**Re: In the Matter of PacifiCorp, dba Pacific Power, 2021 Integrated Resource Plan
(Docket No. LC 77)**

**BEFORE THE PUBLIC UTILITY COMMISSION
OF OREGON**

2021 Integrated Resource Plan

LC 77

Figure 1. Historic Henry Hub prices and PacifiCorp's IRP Natural Gas Price Forecast

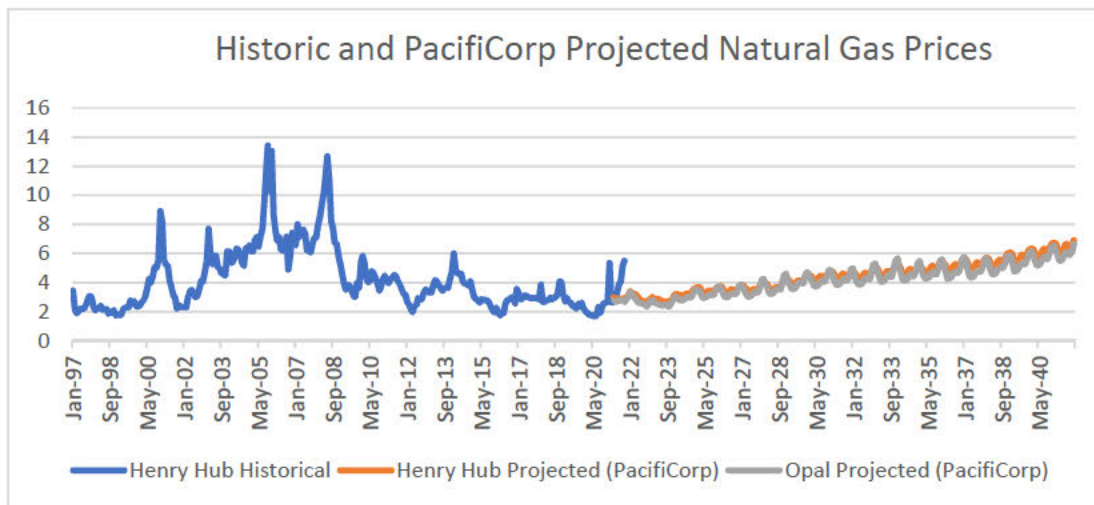
PacifiCorp's IRP forecast expects these low prices to continue for the entire planning horizon. As shown in Figure 1, PacifiCorp's forecast for Henry Hub natural gas prices begins in April 2021 at just under \$3/MMBtu, slowly rise to \$4 in 2029, \$5 in 2034, and ultimately top off at just under \$7/MMBtu by 2041.⁶⁴

Figure 2. Henry Hub Prices Since January 2020, and PacifiCorp's Gas Price Forecast

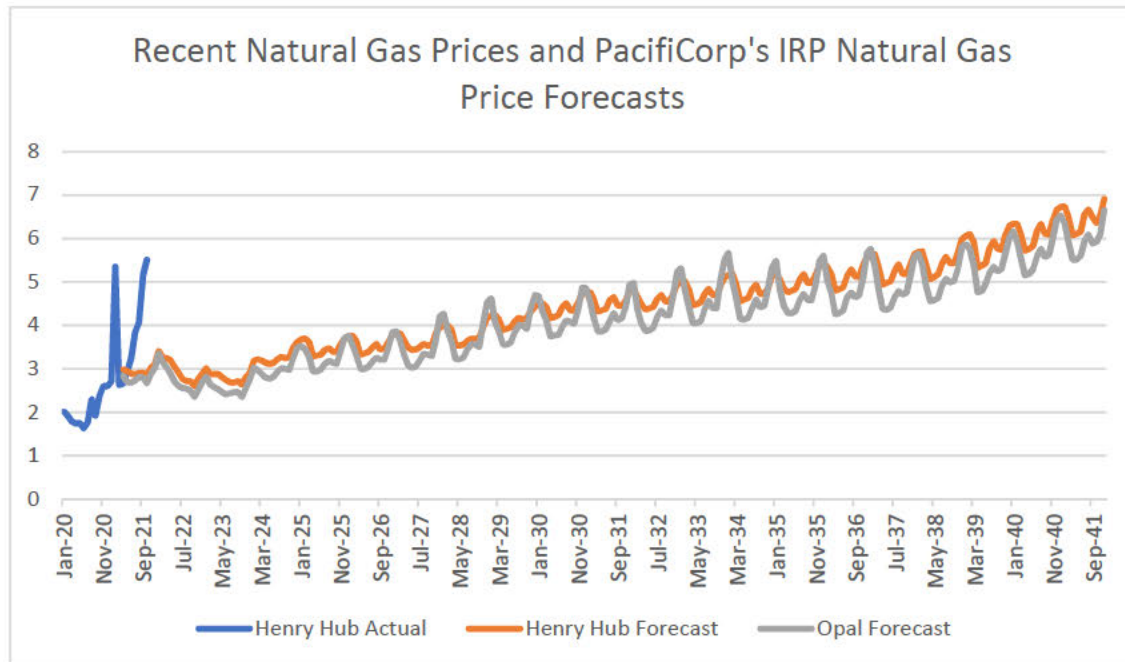
April 2021, actual gas prices have significantly increased relative to the Company’s forecast. In October 2021, the Henry Hub price for gas was \$5.51/MMBtu, nearly double the Company’s forecast of \$2.84/MMBtu.

This year’s dramatic increase in gas prices may be a relative blip and prices could decline once again; however, there is also a real chance high prices could persist as a “new normal.”
